## STAFF REPORT

APPLICATION RZ 1999-DR-012/SE 99-D-015

SPECIAL EXCEPTION PLAN, LANDSCAPE PLAN  
**GRAND DUKE HOTEL, MCLEAN**  
 ESSEXVILLE DISTRICT  
 FARM, J. COUNTY, VIRGINIA

GENERALIZED DEVELOPMENT PLAN, LANDSCAPE PLAN  
**GRAND DUKE HOTEL, MCLEAN**  
 -ESVILLE DISTRICT  
 FA - A COUNTY VIRGINIA

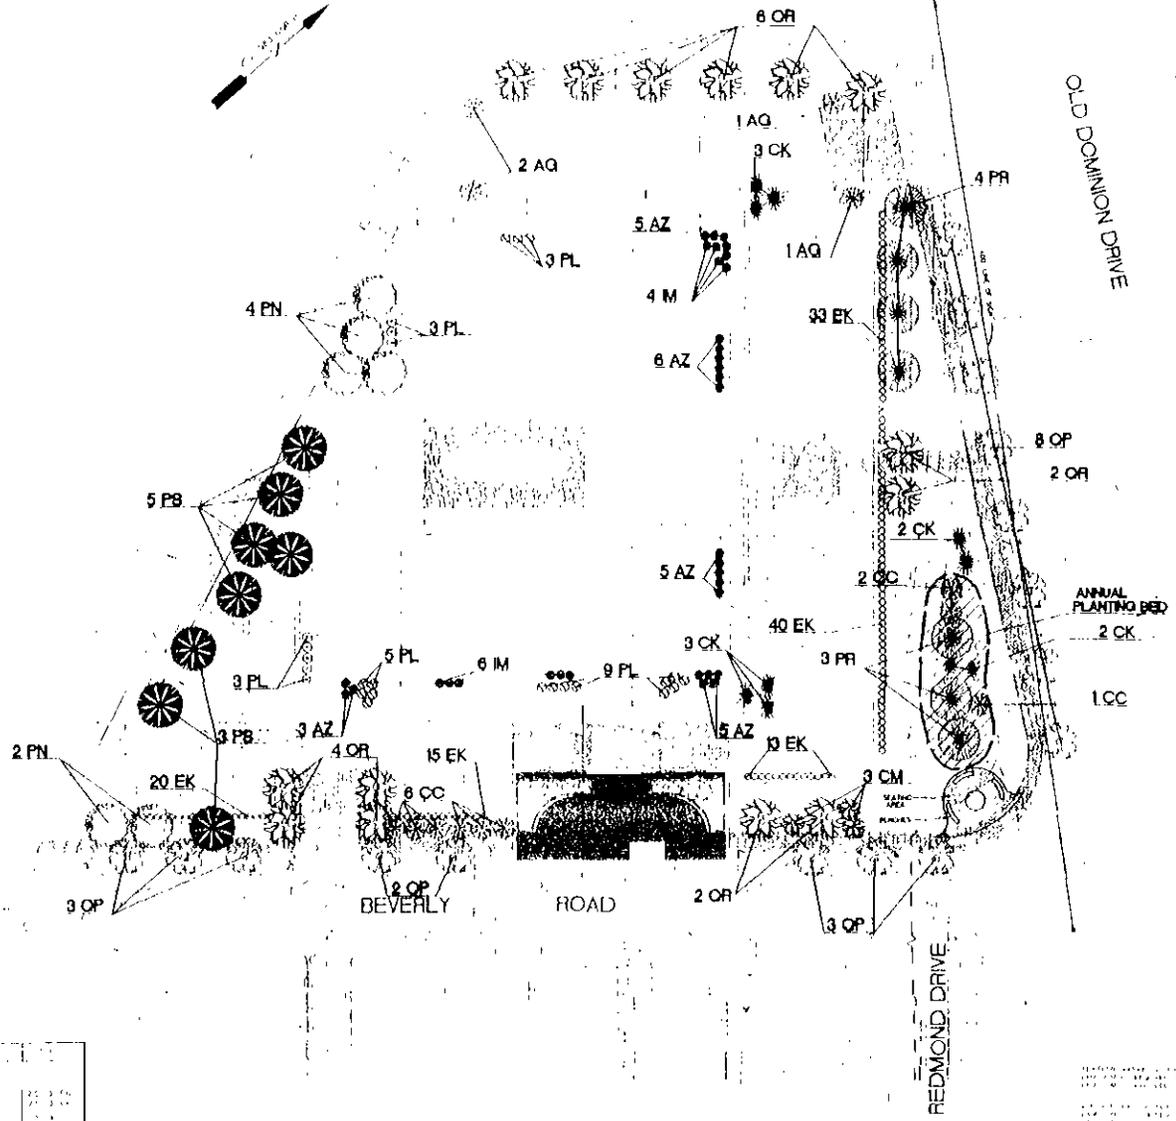
The landscaping depicted on the development plan consists primarily of planting areas along the street frontages to conform with the design guidelines of the McLean CBC Plan. Along Old Dominion Drive, Willow Oak trees are proposed to be planted in a 5 foot wide planting strip located between the sidewalk and the right-of-way. In addition, two Red Oak trees and four Redspire Pear trees are depicted in front of the parking lot and along the sidewalk into the site along Old Dominion Drive. A euonymus hedge is proposed along the Old Dominion side of the site to screen surface parking spaces. Just west of the intersection of Old Dominion Drive with Beverly Road, an annual planting bed with three Redspire Pear trees and dogwood and redbud trees is shown. Along Old Dominion Drive and at the intersection are located numerous utility easements. In addition to the utility easements, a 400 foot VDOT sight line easement runs along the Old Dominion Drive frontage which affects tree placement along the road and near the intersection. The applicant has placed three notes on Sheet 2 which, in summary, allow the landscape plan to change at final site plan submission due to existing easements. Note 2 states that "Landscaping in line-of-sight for sight distance is to be provided if approval is obtained from VDOT and DPWES at time of site plan submission." Note 3 states that "Landscaping shown may be relocated from where shown due to constraints imposed by the holders of existing easements on this site. However, the quantity and quality of the landscaping is not to be diminished by the relocation of landscaping material and is to be in substantial conformance with 'Landscaping, Streetscaping, and Plaza' proffer."

Landscaping along Beverly Road is also oriented toward the street and consists of Willow Oak trees in the planting strip between the sidewalk and the right-of-way and Red Oak trees inside the sidewalk. The Red Oak tree nearest the plaza on Beverly Road is located within the storm sewer easement and must be relocated. Dogwood and redbud trees are proposed inside the sidewalk on either side of the plaza. Adjacent to Parcel 22A which is developed with an office, Austrian and Scotch pine trees are proposed. Foundation plantings consisting of azaleas, laurel,

Staff has long been concerned about the applicant's landscaping proposal along Old Dominion Drive and at the intersection because of the existing utility easements and the VDOT sight line. The applicant's notes and proffers attempt to address the issue by proposing to relocate some of the plantings shown to other locations if easements preclude planting as shown. Trees proposed to be located in the sight line would not be planted unless approved by VDOT. It is staff's position that the landscaping depicted on the GDP should be realistic and take into consideration all known site constraints. There may not be alternate locations on the site to which the plantings can be relocated and the Plan emphasizes plantings along the streets. At the request of staff, the applicant submitted an exhibit showing all of the easements on the site. The exhibit, labelled Exhibit 1 is attached behind the reductions of the GDP and SE Plat at the front of the report. Since the applicant did not provide requested information about permitted planting in the various easements, staff consulted with representatives from the Department of Public Works Maintenance and Construction Division, the Site Review Branch of DPWES, and the Urban Forestry Branch of DPWES to determine how much of the applicant's proposed landscaping would be permitted at the time of site plan approval. It was determined that none of the Willow Oak trees proposed along Old Dominion Drive could be planted as shown because of the VDOT sight distance easements. With the applicant's Note 2 on the Landscape Plan, these trees would not be required. In addition, the presence of a storm sewer easement along both

Old Dominion Drive and a portion of Beverly Road preclude the planting of two (2) Willow Oak trees proposed to flank the sidewalk leading from Old Dominion Drive to the hotel entrance and two sections of hedge in front of the parking lot adjacent to the intersection. One possible solution to this problem involves shifting the proposed sidewalk along Old Dominion Drive further into the site to increase the width of the planting strip between the street and the sidewalk so the trees can be relocated out of the sight distance area. This approach would move the sidewalk out of the right-of-way which would require a public access easement and a maintenance agreement with VDOT. VDOT has verbally agreed to maintain the proposed 7.5 foot wide brick paver sidewalk if it is located within a public access easement; however, the commitment will not be put into writing until VDOT has seen a revised plan. The applicant is currently developing a revised landscape plan to address the issue. As submitted, the applicant's landscape plan does not address Plan guidelines and misrepresents the amount of landscaping that would actually be planted along Old Dominion Drive.

the sight distance easement. In addition, the Plan calls for benches at the entrances to the building and bulb and perennial plantings which are not shown on the applicant's development plan. Staff has proposed development conditions to require benches and the bulb and perennial plantings, as recommended in the Plan.

GENERALIZED DEVELOPMENT PLAN, ILLUSTRATIVE PLAZA PLAN  
**GRAND DUKE HOTEL, McLEAN**  
 PRINCETONVILLE DISTRICT  
 PUBLIC DEVELOPMENT BOARD

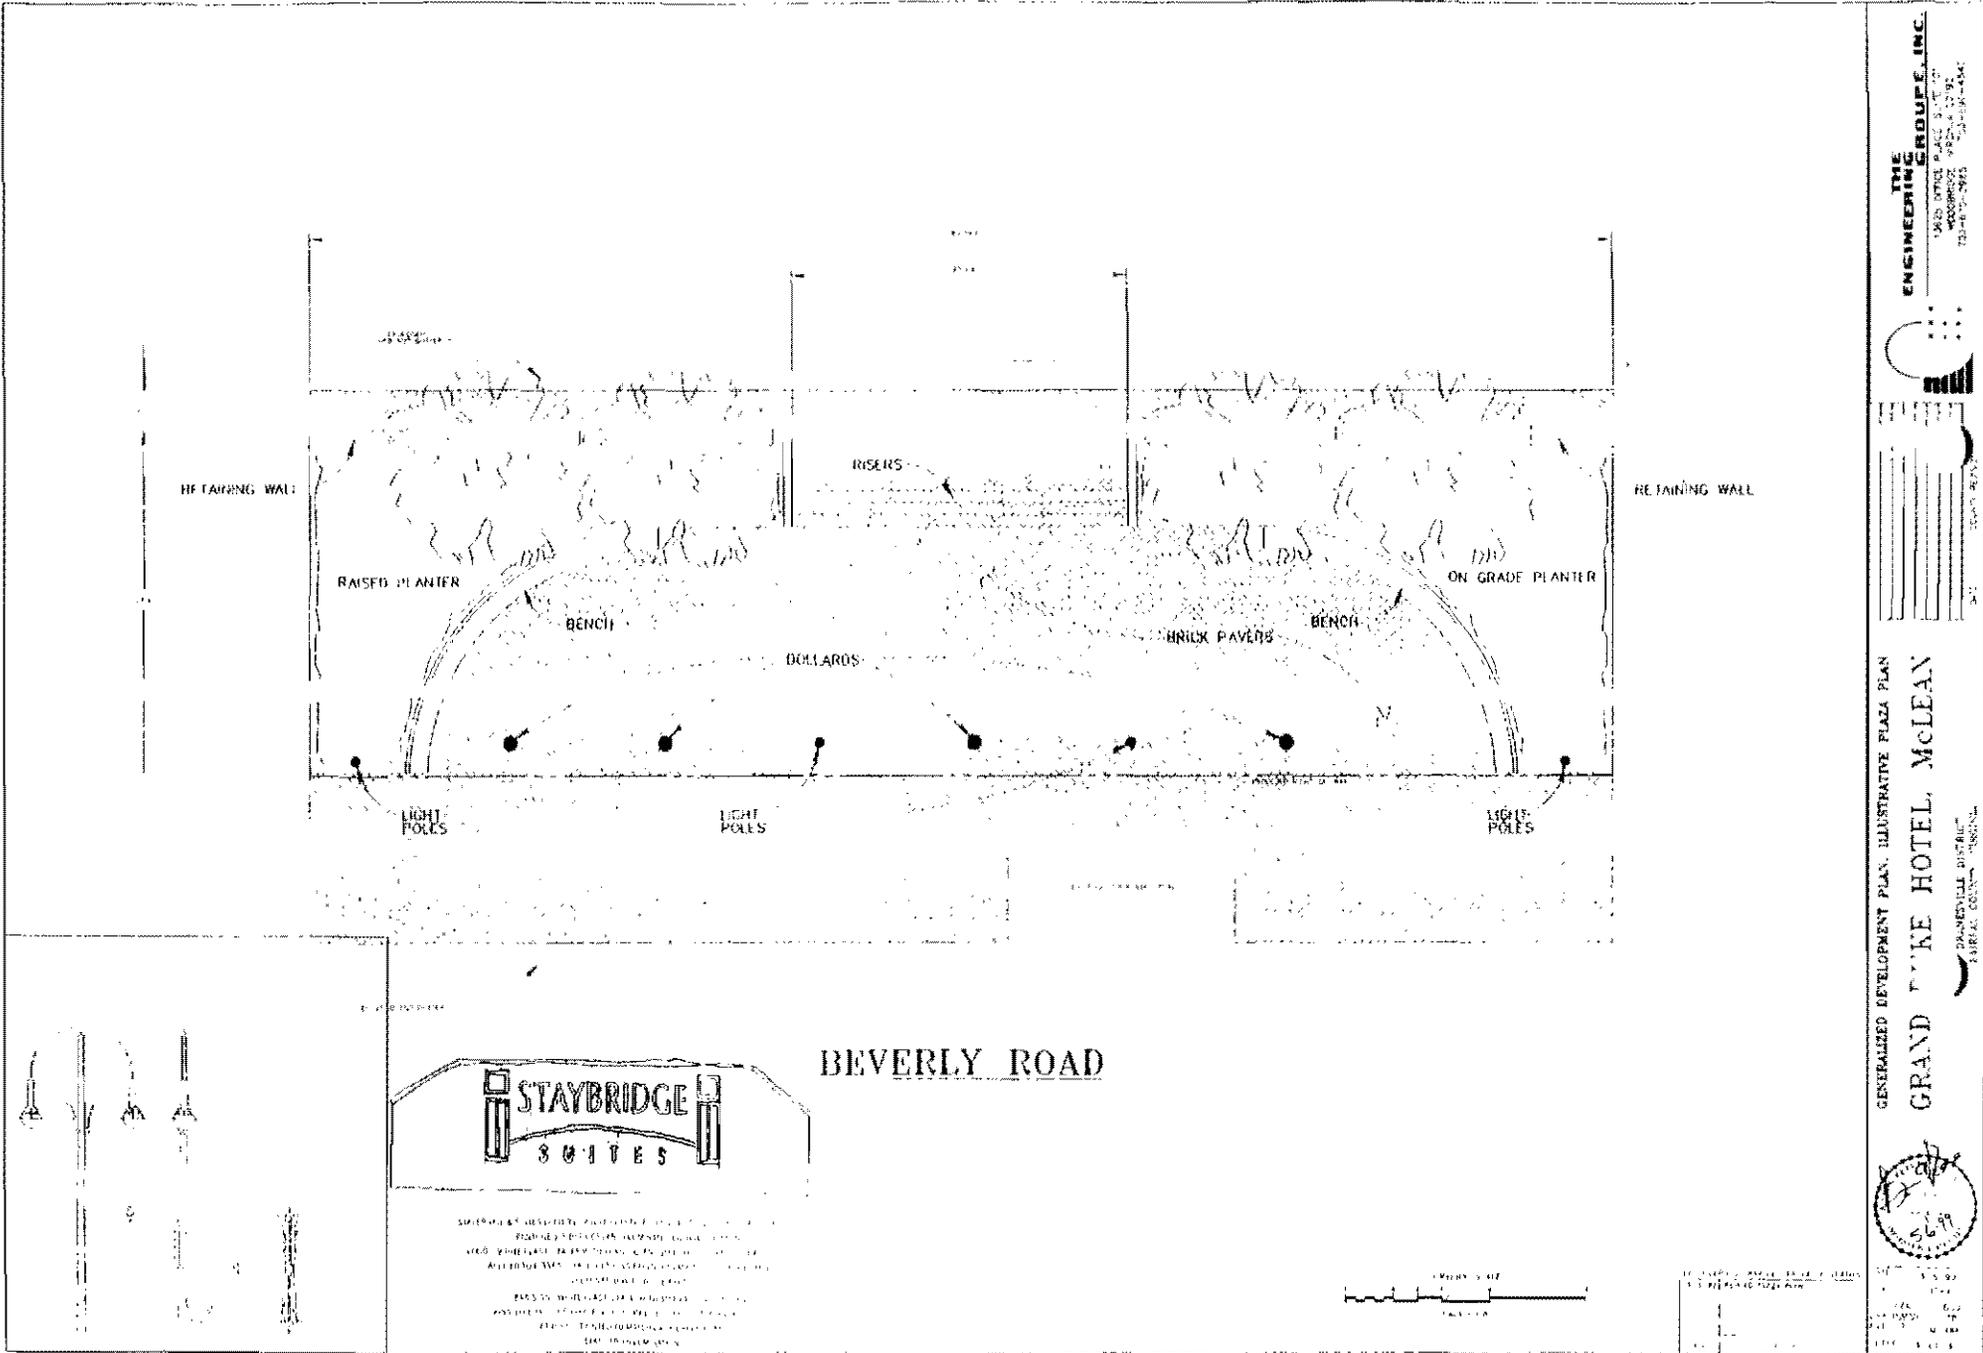
**Sheet 3** of the GDP contains the plan for the Plaza along Beverly Road and signage and lighting details. The proposed plaza is approximately 90 feet in width and 37 feet deep and is located between the hotel entrance and driveway and Beverly Road. Approximately 11 feet of the plaza depicted is located within proposed right-of-way. The plaza is an area intended by the Comprehensive Plan to be used by the public as an after hours activity generator and as a critical terminus for the proposed new "main street" which will be developed in the McLean Shopping Center which is located opposite the site, across Beverly Road. The Land Use Addendum notes that, with either the hotel or an office, the applicant would need to provide assurances that the public assembly area (plaza) would be available to the public and that the developer would be responsible for its maintenance. The applicant has stated that the proposed plaza is "private" but could be used to some extent by the public. Staff had originally requested the applicant to commit to record a public access easement on the plaza; however, the applicant is not willing to do this. Staff has, therefore, requested a proffer which clearly states the terms and conditions for the public's use of the plaza. Absent that proffer, staff has proposed a development condition which requires the applicant to record a public access easement on the plaza to insure that it will be open to the public. However, the development condition would only govern if the proposed hotel is developed and would not ensure that the plaza remain public if another use is developed. The "main street" does not currently exist; however, renovations in the shopping center are currently taking place and the "main street" is planned for a future phase of the construction. The applicant has proffered to provide \$27,360.00 to DPWES at the time of final site plan approval for construction of a brick/paver crosswalk across Beverly Road, within VDOT right-of-way to connect the plaza with the new "main street". If the crosswalk is not constructed within 18 months following the applicant's escrow deposit, the escrow shall be released to the applicant. As stated previously, this 18 month time limit is not realistic and should be deleted. The plaza is shown constructed with brick pavers with planters and benches flanking each side of risers leading to the hotel entrance area. Light poles and bollards are located along the edge of the right-of-way on the hotel property. A sign for Staybridge Suites is detailed on this sheet; however, there are no dimensions shown and no location specified.

Criteria #3 states that "Open space and public areas are provided per the McLean CBC Design Standards". It is suggested that a water feature be provided in the public area (plaza), as recommended in the concept diagram on page 11 of the Public Space Design Standard S, C. Special Place-Mid Block. Other options could be an outdoor sculpture or a distinctive planter, or a combination of the two. Creating a special design treatment in the center of this plaza is important because the size of the proposed plaza is barely adequate for a public assembly function. According to the Special Place-Mid Block recommendations, a mid-block special place should be a plaza area that is designed as a dramatic terminal point for a major pedestrian concourse. The open space area or plaza should have architectural embellishments, planting and seating with distinctive paving and

include shade and/or ornamental trees. The plaza is proposed in the Plan as a gathering place and an activity generator. The applicant's proposed plaza is lacking in its provision of the recommended embellishments and, as discussed earlier, no specific commitment to the public use of the plaza has been made by the applicant. The proposed plaza provides benches and planters; however, no plant legend is provided so it is not clear what will be planted. There are no other "architectural embellishments". According to the applicant, he intends to submit a revised and improved plan for the plaza. In staff's analysis, major improvements are needed in the plaza if it is to meet the spirit and intent of the Plan.

The McLean Central Business Center (CBC) Open Space Design Standards, Public Space Design Standards contain lighting standards which apply to this site. According to the Land Use Analysis, additional details on location, size, and orientation of light fixtures should be provided. Sheet 4 of the applicant's GDP shows some lighting details which are consistent with that shown on page 53 of Appendix 7 of the McLean Plan; however, no information is given regarding where the applicant proposes to use them, with the exception of in the plaza on Beverly Road.

OLD DOMINION DRIVE - FRONT ELEVATION

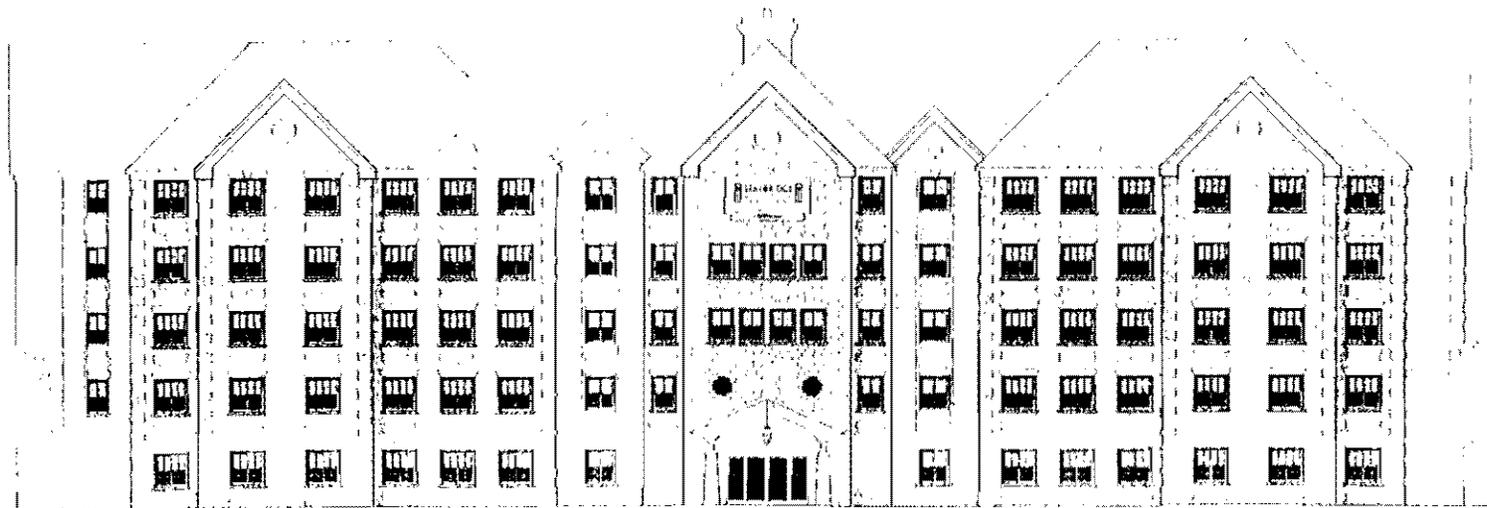
**Sheet 4** of the GDP shows the Old Dominion and Beverly Road elevations of the proposed hotel. Both facades contain entrances to the building with a building mounted sign above each entrance. The hotel is depicted as a five-story hotel constructed of primarily brick with stone accents with a pitched roof. No details of building materials or colors are provided on this sheet; however, the applicant's draft proffer states that the "The hotel structure shall be of an architectural style and quality comparable to the elevations on Sheet 4 of the GDP. Brick portions of the

building facade shall be predominantly earth-toned red brick ("Virginia Brick"). Staff has proposed a development condition which requires the hotel to be constructed with brick similar to that used in the Riggs Bank which reflects the agreement between the applicant and the McLean Planning Committee (see the motion attached to the applicant's Statement of Justification).

5. The hotel shall be constructed primarily of Virginia Brick similar to that used in the Riggs Bank Building located at 6805 Old Dominion Drive in McLean. The building design shall be in substantial conformance with that shown on Sheet 4 of the Generalized Development Plan submitted with RZ 1999-DR-012 which is dated March 8, 1999, with a revision date of April 5, 1999. The roof shall be a dark earthtone, gray, or black, as approved by DPWES.
